PROPOSED CHANGE RTS-181 TO THE
DUANE ARNOLD ENERGY CENTER
TECHNICAL SPECIFICATIONS

Summary

Subject: Duane Arnold Energy Center
Docket No: 50-331
Op. License No: DPR-49
Technical Specification Changes (RTS-181)
Update of NDT Operating Limit Curves
File: A-117, J-40b

Figure 3.6-1. Pressure versus Minimum Temperature Valid to Twelve Full Power Years, per Appendix G of 10CFR50

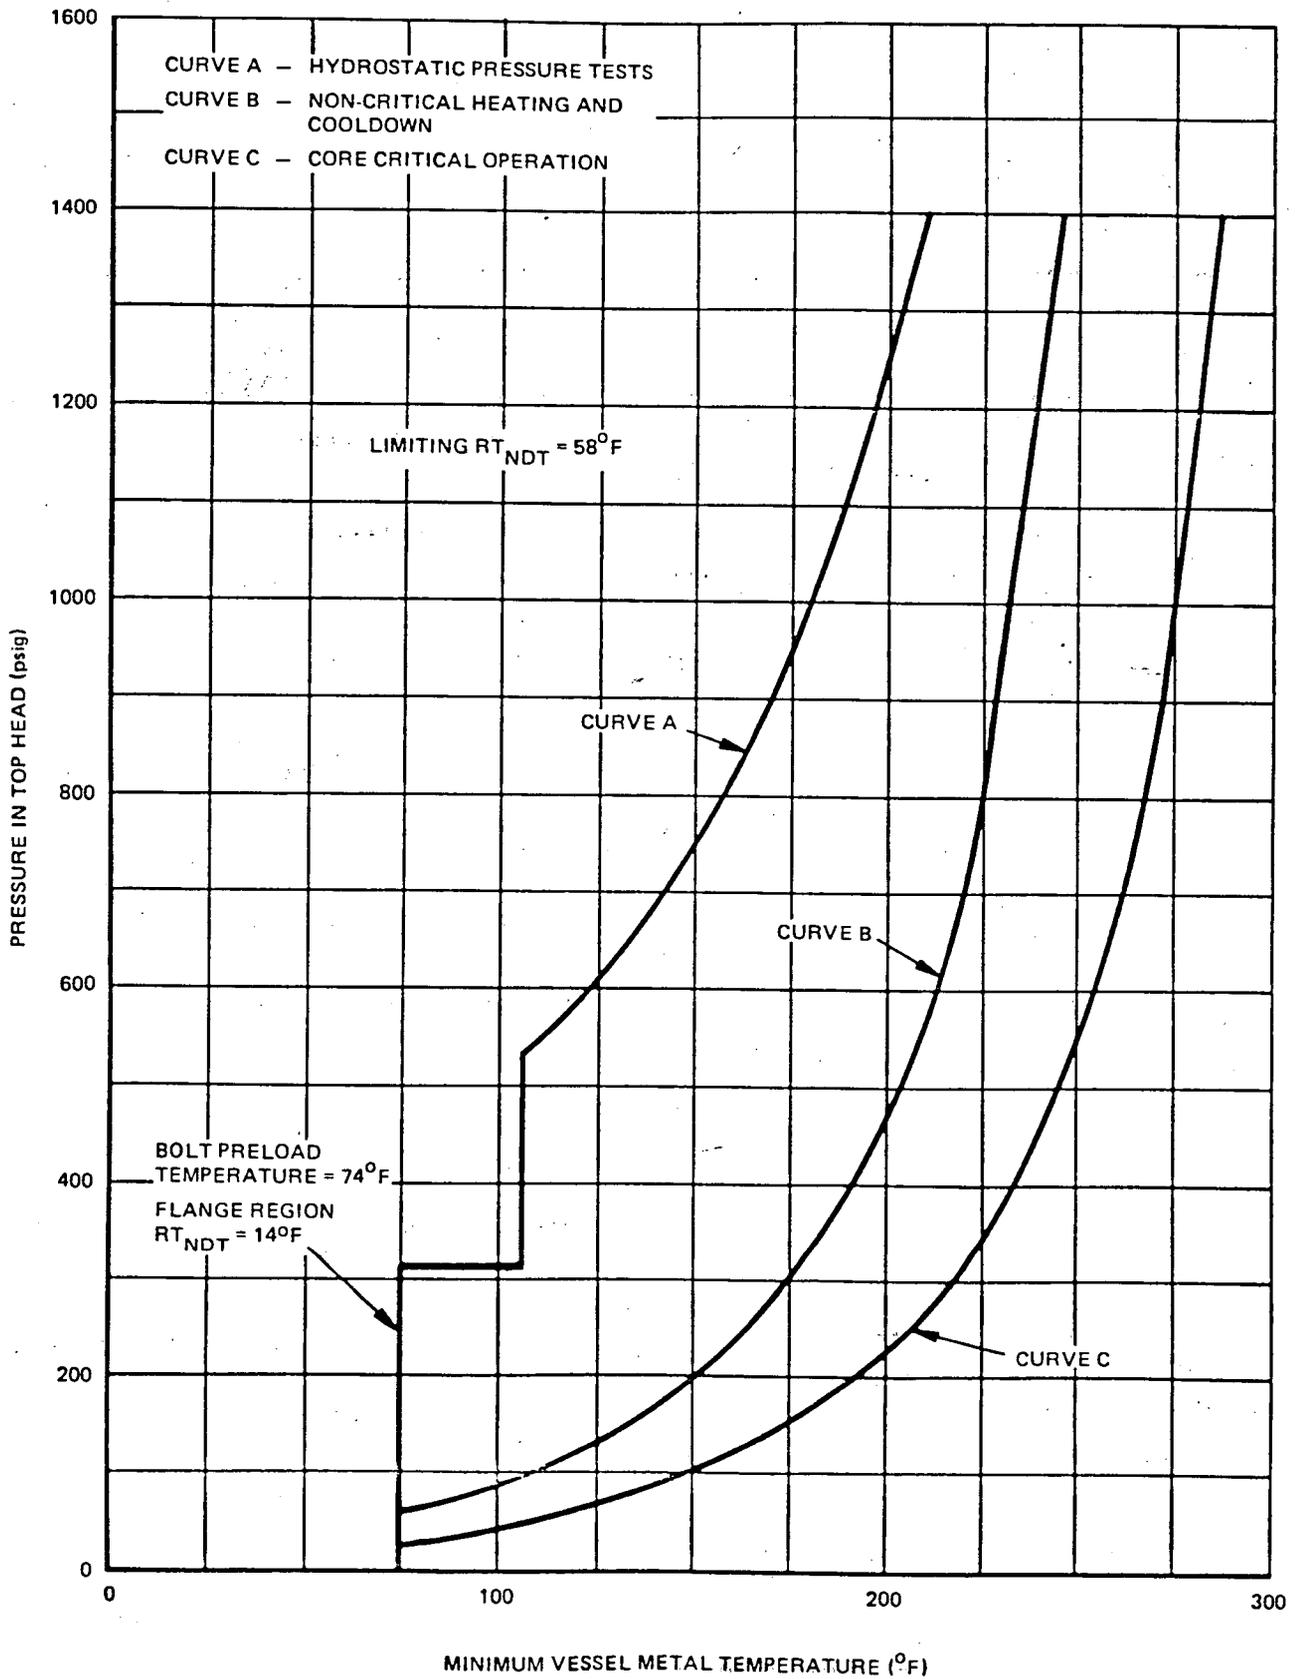
- 1) On page 3.6-1, paragraph 3.6.A.2 is revised to make Figure 3.6-1 valid through 12 effective full power years instead of 6.
- 2) On page 3.6-2, the minimum temperature for which bolting studs can be in tension is lowered from 100°F to 74°F. Calculations have shown that the former limit of 100°F was too conservative when established and was much higher than is necessary or practical.

- 8) On page 3.6-16, the reference to the FSAR is revised to reference the Updated FSAR and the new appendix.
- 9) On pages 3.6-17 and 3.6-18, the paragraph which discusses the NDT temperature is replaced by two paragraphs which discuss the derivation of and the influences on the NDT curves and the minimum operating temperature of the closure flange region.
- 10) On page 3.6-49, the NDT curves of Figure 3.6-1 are revised to be valid through 12 effective full power years.

The operating limits in Figure 3.6-1 are derived in accordance with 10 CFR 50 Appendix G, May 1983 and Appendix G of the ASME Code. Conditions in three regions influence the curves: the closure flange region, the non-beltline region which includes most nozzles and discontinuities, and the beltline region which is irradiated with fluence above 10^{17} n/cm² during the vessel operating life. Irradiation causes an increase in the nil-ductility temperature (RT_{NDT}) of the beltline materials, possibly to the point where the beltline region impacts the pressure-temperature limits for the vessel. However, for Figure 3.6-1, effective to 12 EFPY, the beltline which has an

RT_{NDT} of $40^{\circ}F$ is less limiting than the non-beltline regions which generally experience higher stresses at nozzles and discontinuities. The limiting RT_{NDT} of $58^{\circ}F$ for the Standby Liquid Control Nozzle (N10) is the highest RT_{NDT} of any component in the non-beltline region.

The closure flange region, with $RT_{NDT} = 14^{\circ}F$, has a bolt preload and minimum operating temperature of $74^{\circ}F$. This exceeds original requirements of the ASME Code (Winter 1967 Addendum) and provides extra margin relative to current ASME Code requirements.

Figure 3.6-1. Pressure versus Minimum Temperature Valid to Twelve Full Power Years, per Appendix G of 10CFR50

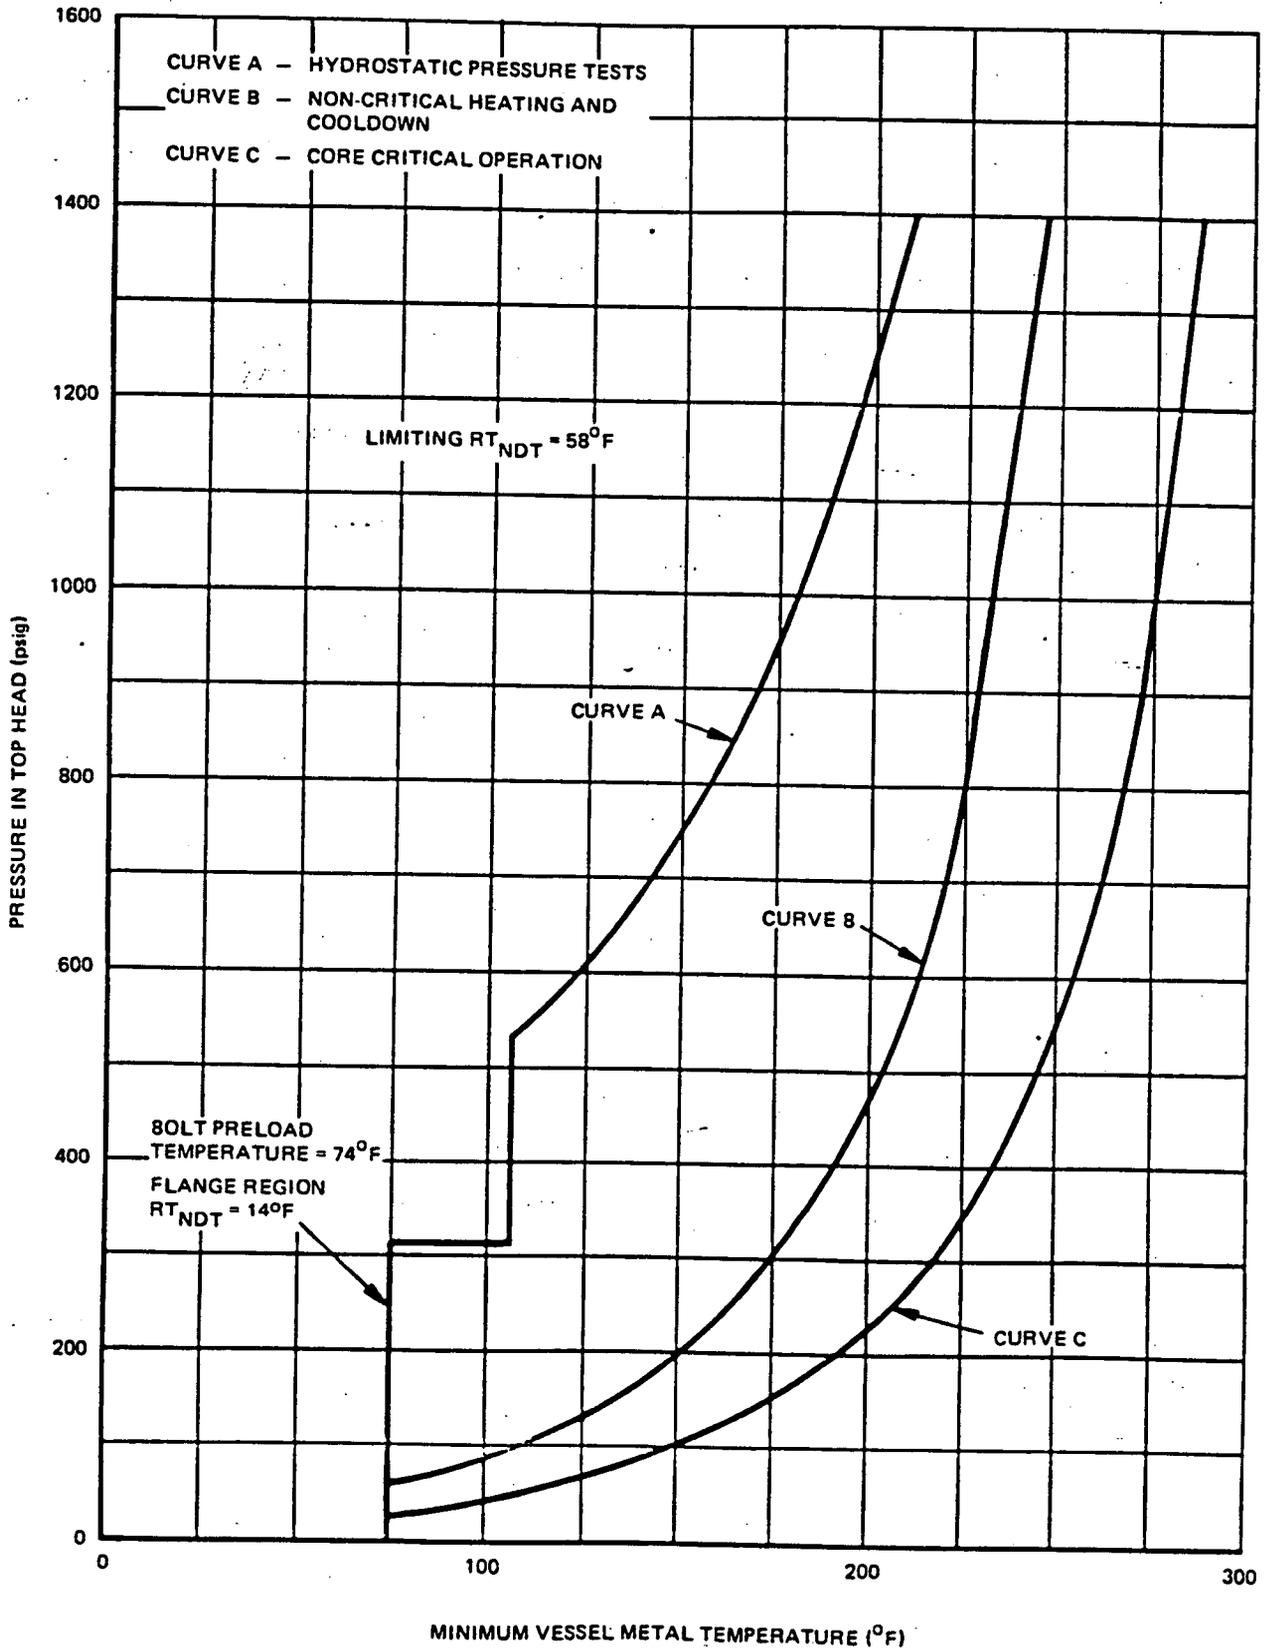
- 1) On page 3.6-1, paragraph 3.6.A.2 is revised to make Figure 3.6-1 valid through 12 effective full power years instead of 6.
- 2) On page 3.6-2, the minimum temperature for which bolting studs can be in tension is lowered from 100°F to 74°F. Calculations have shown that the former limit of 100°F was too conservative when established and was much higher than is necessary or practical.

- 8) On page 3.6-16, the reference to the FSAR is revised to reference the Updated FSAR and the new appendix.
- 9) On pages 3.6-17 and 3.6-18, the paragraph which discusses the NDT temperature is replaced by two paragraphs which discuss the derivation of and the influences on the NDT curves and the minimum operating temperature of the closure flange region.
- 10) On page 3.6-49, the NDT curves of Figure 3.6-1 are revised to be valid through 12 effective full power years.

The operating limits in Figure 3.6-1 are derived in accordance with 10 CFR 50 Appendix G, May 1983 and Appendix G of the ASME Code. Conditions in three regions influence the curves: the closure flange region, the non-beltline region which includes most nozzles and discontinuities, and the beltline region which is irradiated with fluence above 10^{17} n/cm² during the vessel operating life. Irradiation causes an increase in the nil-ductility temperature (RT_{NDT}) of the beltline materials, possibly to the point where the beltline region impacts the pressure-temperature limits for the vessel. However, for Figure 3.6-1, effective to 12 EFPY, the beltline which has an

RT_{NDT} of 40°F is less limiting than the non-beltline regions which generally experience higher stresses at nozzles and discontinuities. The limiting RT_{NDT} of 58°F for the Standby Liquid Control Nozzle (N10) is the highest RT_{NDT} of any component in the non-beltline region.

The closure flange region, with RT_{NDT} = 14°F, has a bolt preload and minimum operating temperature of 74°F. This exceeds original requirements of the ASME Code (Winter 1967 Addendum) and provides extra margin relative to current ASME Code requirements.
